THOMSONS LAKE URBAN STRUCTURE STUDY AND SOUTH JANDAKOT
DEVELOPMENT WATER RESOURCES MANAGEMENT PLAN

MINISTERIAL CONDITION 2

Report and Recommendations
of the
Environmental Protection Authority

Bulletin 388 May 1989

Figure 3. Proposed Urban Drainage System.

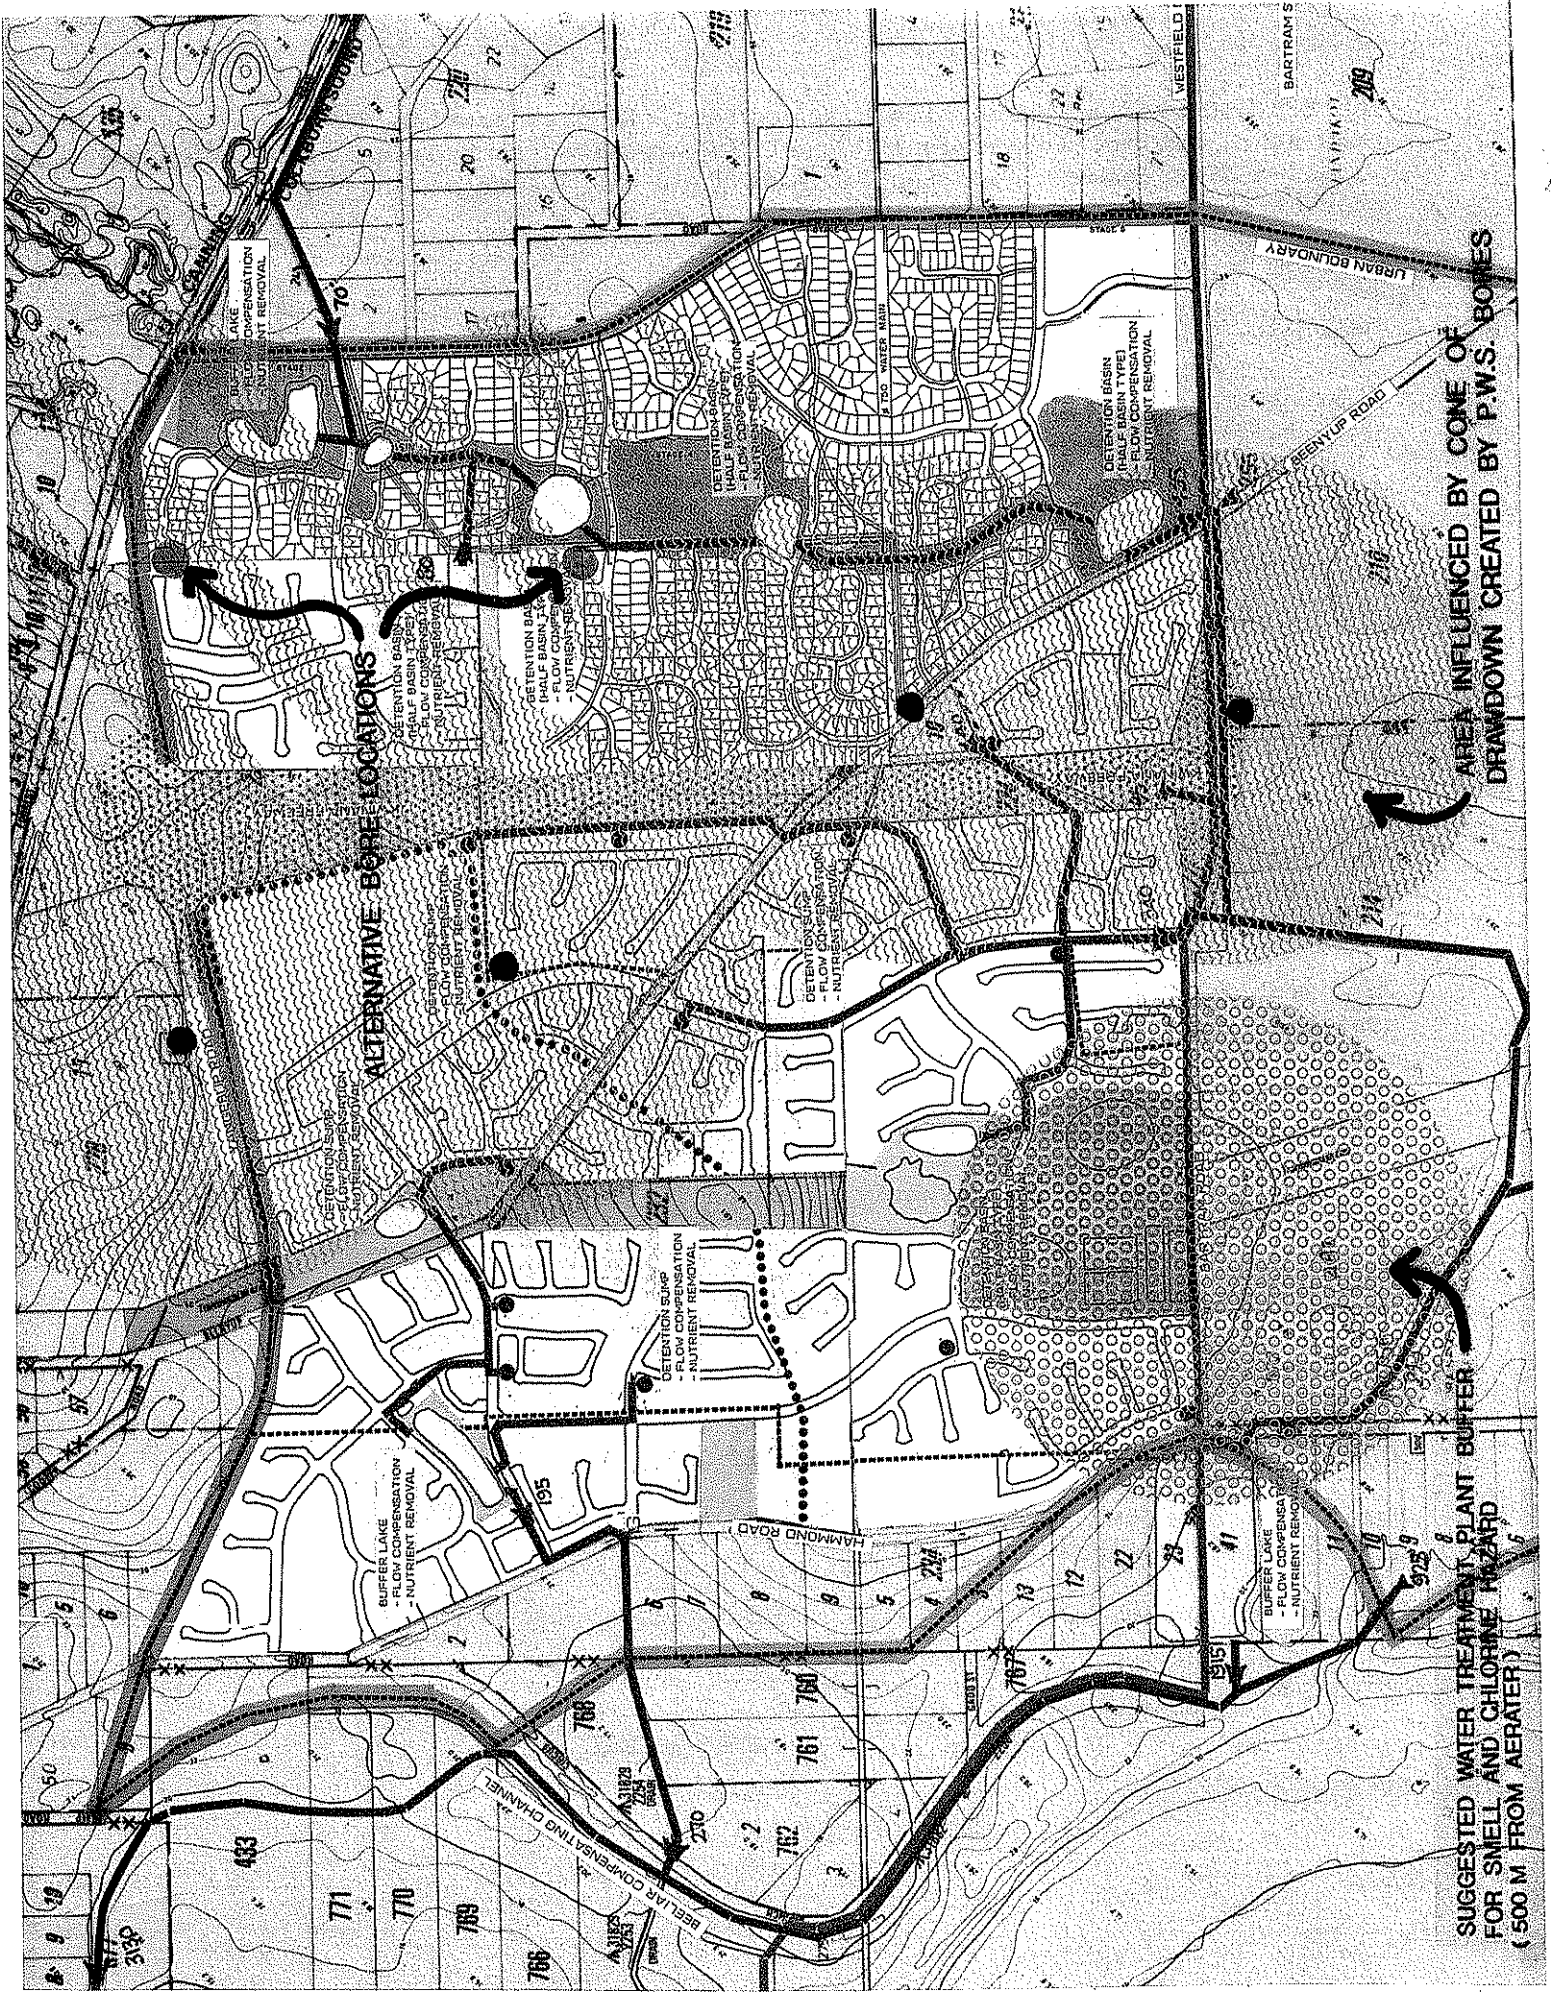
Some government Departments believed the management plan was inadequate and seven submissions indicated the proposal was vague. For example the locations of the compensating basins are not shown on maps or discussed, may not work effectively and may therefore be unable to protect the Beelias wetlands.

13. The impact and cost of post-development management need to be addressed.
14. More accurate details on the alignment of the channel are needed. Suggestions are made in the submissions that the alignment needs to be moved in some areas to avoid environmentally valuable areas, homes and factories. It was considered that consideration should be given to acquiring land rather than obtaining easements over land (page 8).
15. Clarification is required as to how the channel will assist in reducing the midge and mosquito problem.
16. There needs to be a clear indication that the drainage system will operate effectively in wet years.
17. More information needs to be provided about the impact of clearing on the proposal and surrounding areas.
18. Some submissions expressed the view that a full Environmental Review and Management Programme should have been prepared.

Figure 4. Proposed Beelihar Compensating Channel.

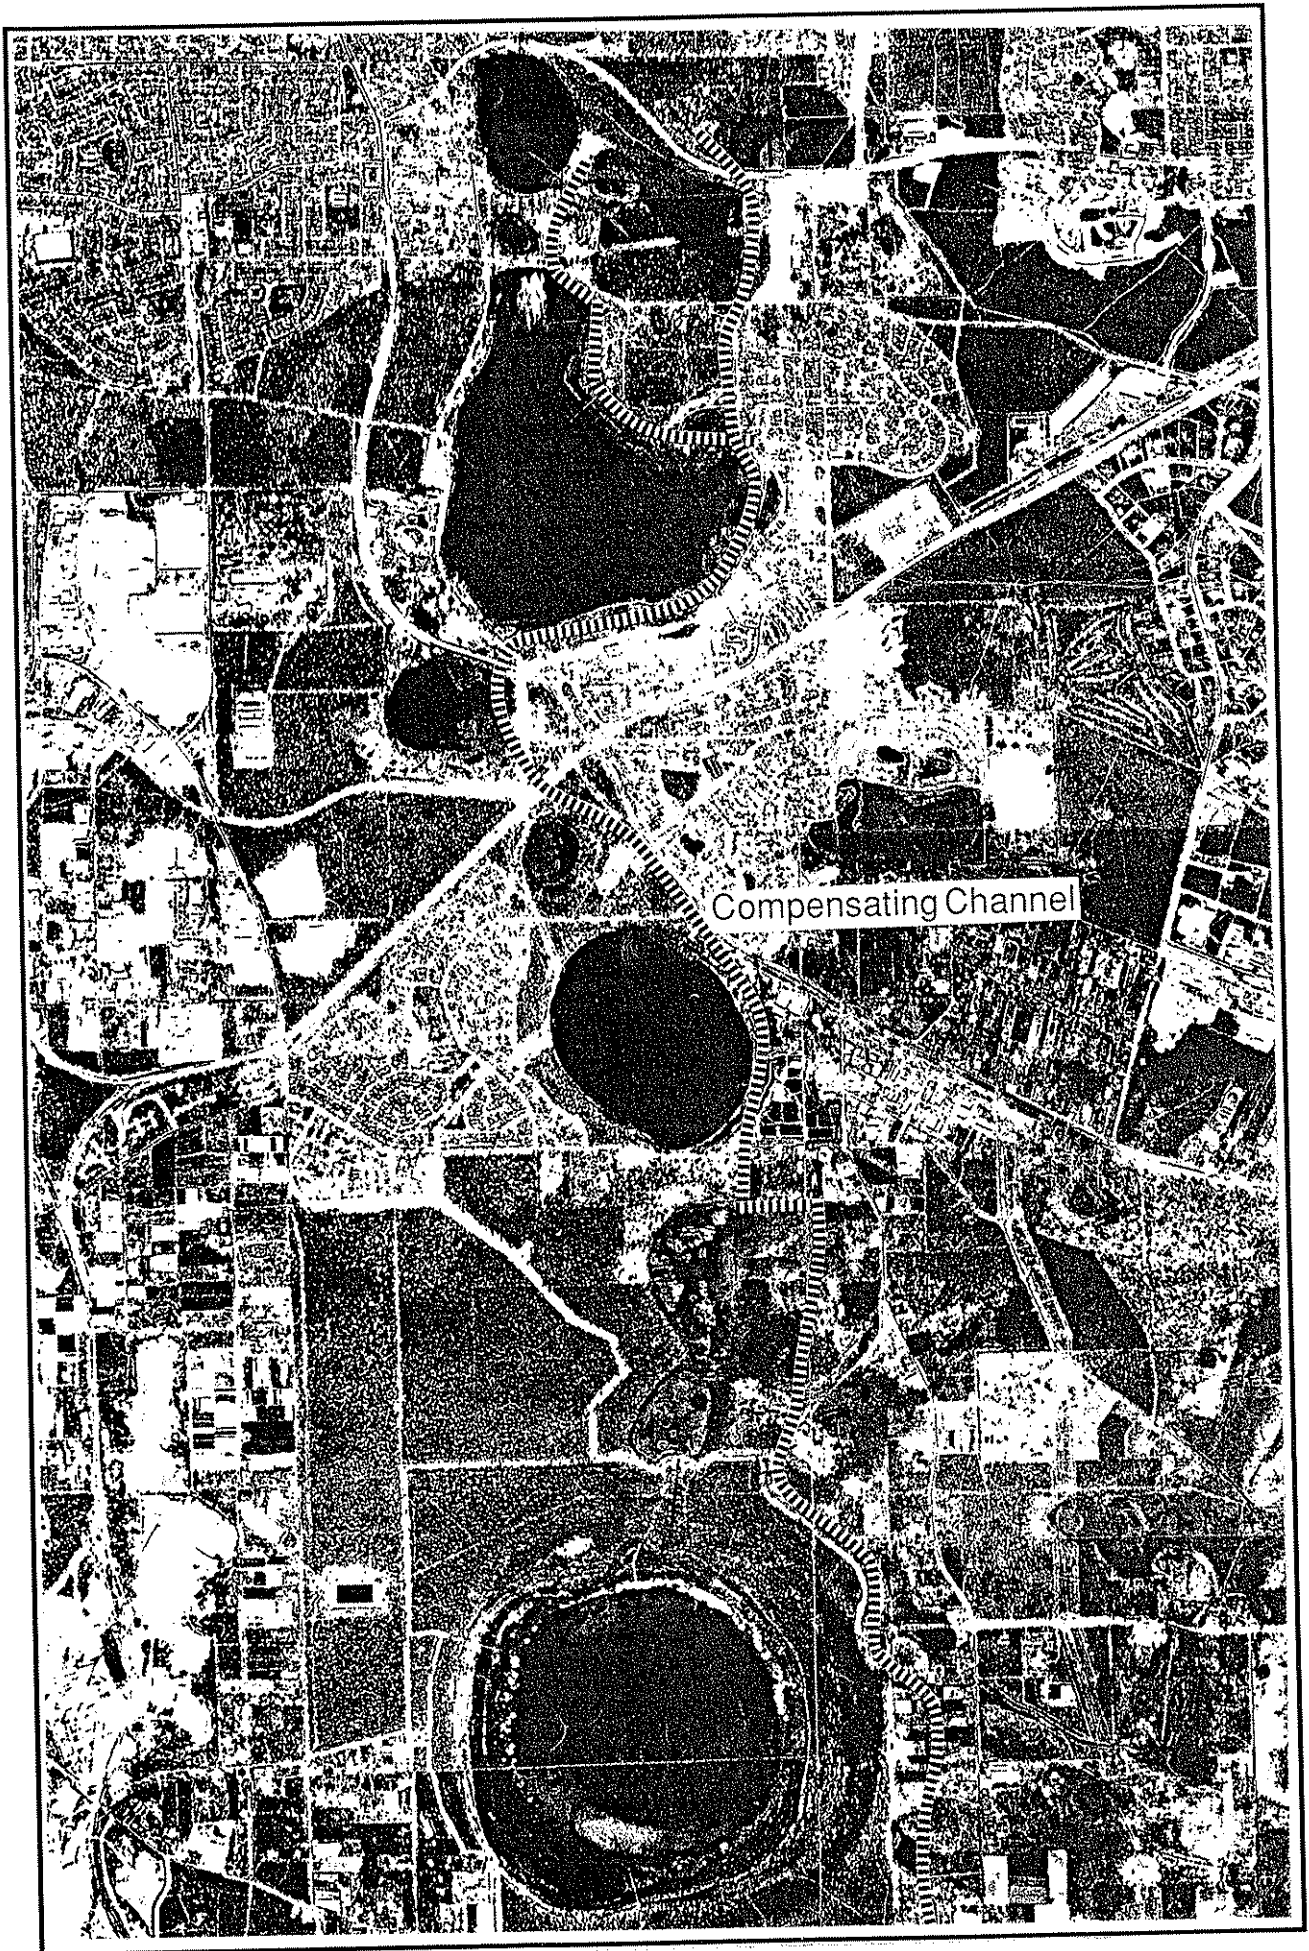
The Technical Advisory Group concluded that, while the concept of the Beeliar Compensating Channel has merit, it was not satisfied that the drainage management plan in its present form demonstrated that the Beeliar wetlands would be adequately protected (Technical Advisory Group, 1989). That is, the Technical Advisory Group advised the Environmental Protection Authority in effect that it did not consider that the Minister's Condition 2 had been fulfilled.

- 2.3 The management plan should address the hydraulic and environmental functions of both the northern and southern sections of the proposed channel. According to one submission there is a lack of evidence that the channel will function hydraulically and that the quantities of water to be transported have been accurately assessed. Another submission suggested a drainage system with a greater carrying capacity is required and two others considered that the system may not be sufficient to prevent flooding of the urban development and flow rates in the channel may be underestimated. Concern is expressed about part of the drain near Bartrum Road being below the watertable for six months each year. This conflicts with claims that wetlands near Bartrum Road may be drained by this channel. These wetland were supposed to be protected as part of the Beelihar Regional Park.

Figure 6. Areas Relatively Unconstrained for Urban Development.

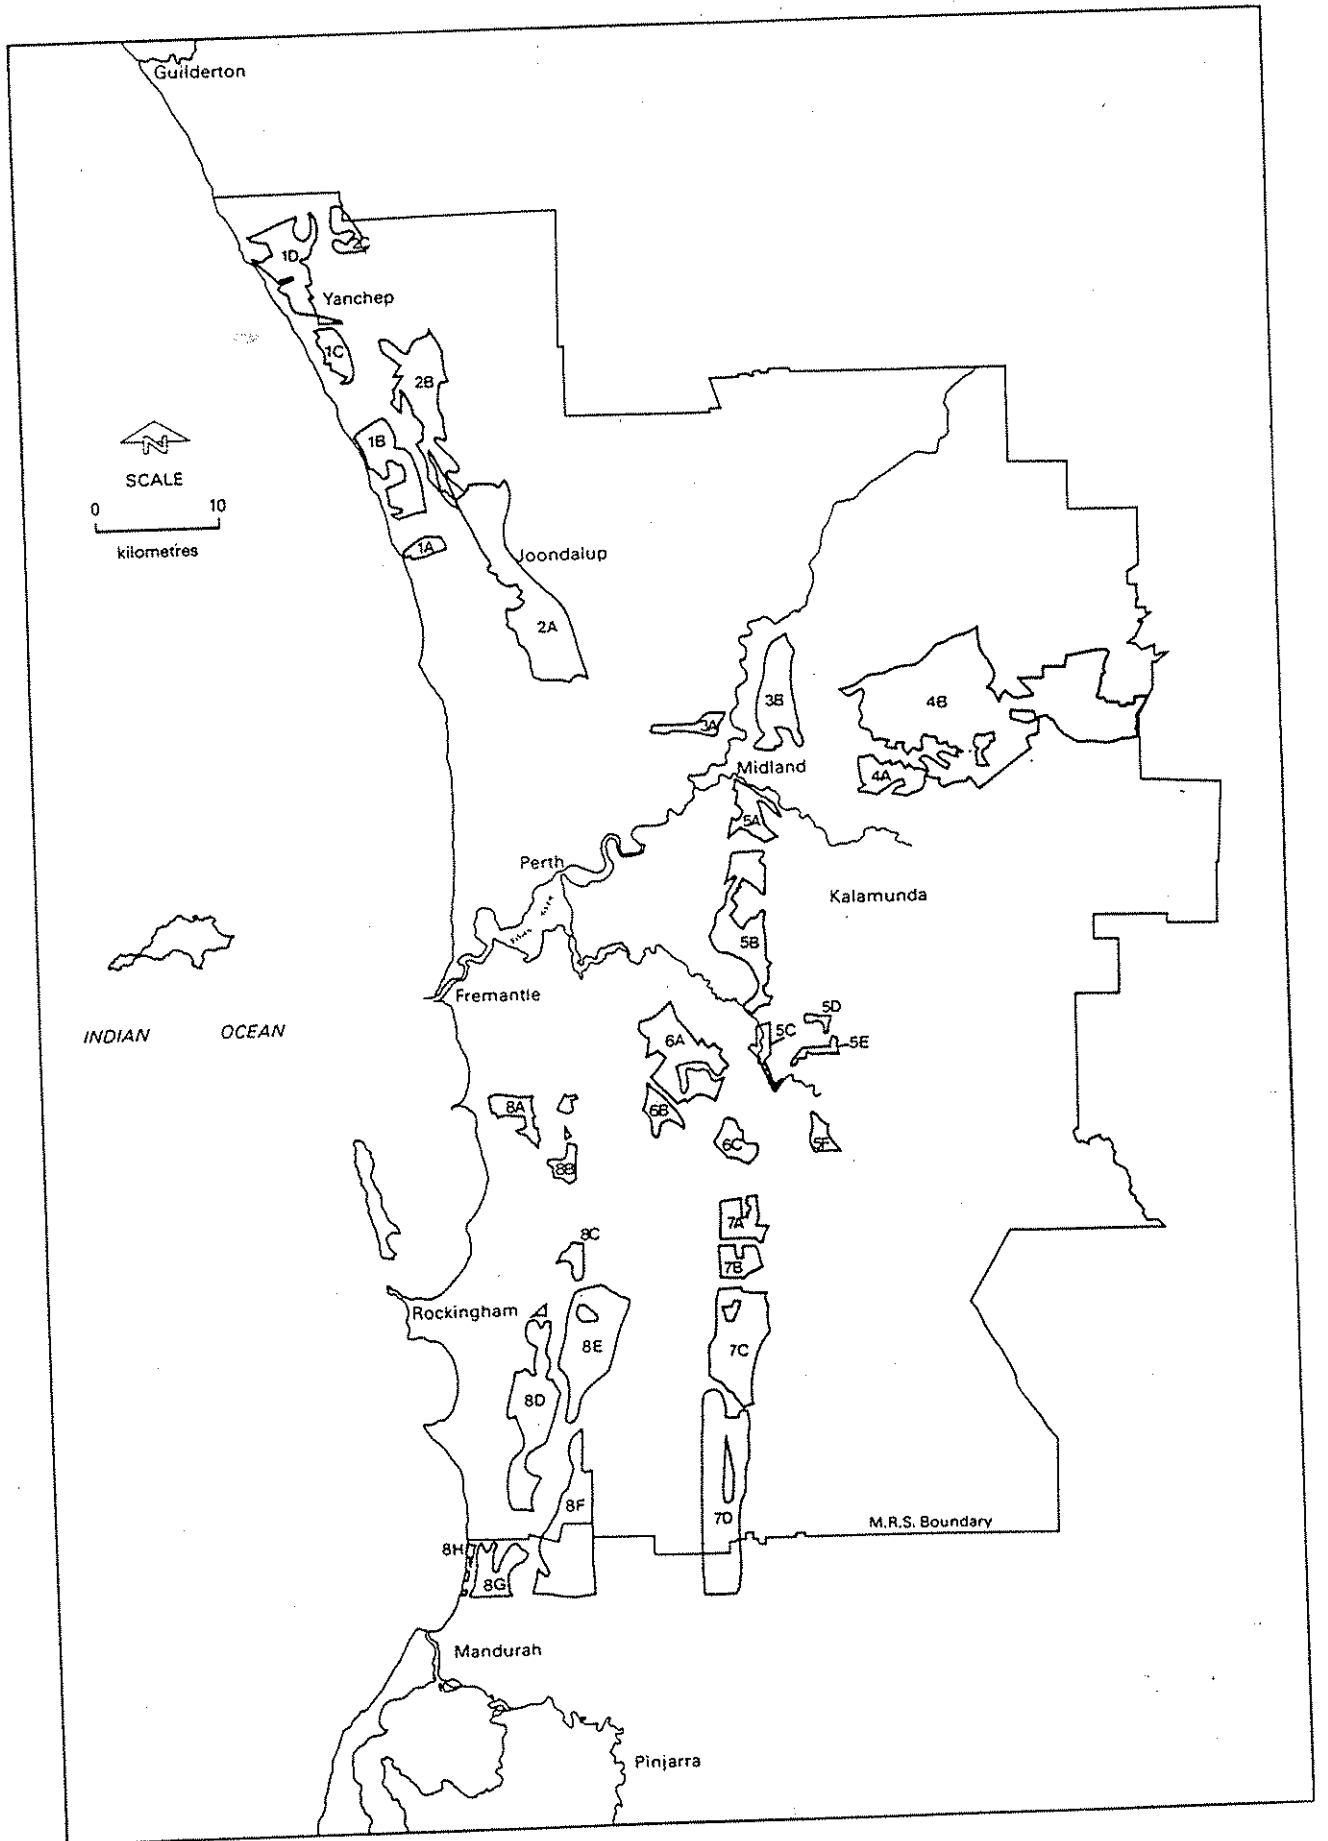
A working paper released in conjunction with the State Planning Commission's report, "Planning for the Future of the Perth Metropolitan Region", identified potential urban development areas in the metropolitan region. The working paper, which takes into account environmental constraints, suggests that there are substantial areas south of the Swan River which are relatively unconstrained for urban expansion. A figure from that report has been reproduced here to demonstrate this point (Figure 6).

It seems appropriate that land identified in the State Planning Commission's report as being relatively unconstrained for urban development be further investigated and acceptable areas proceeded with as a priority.
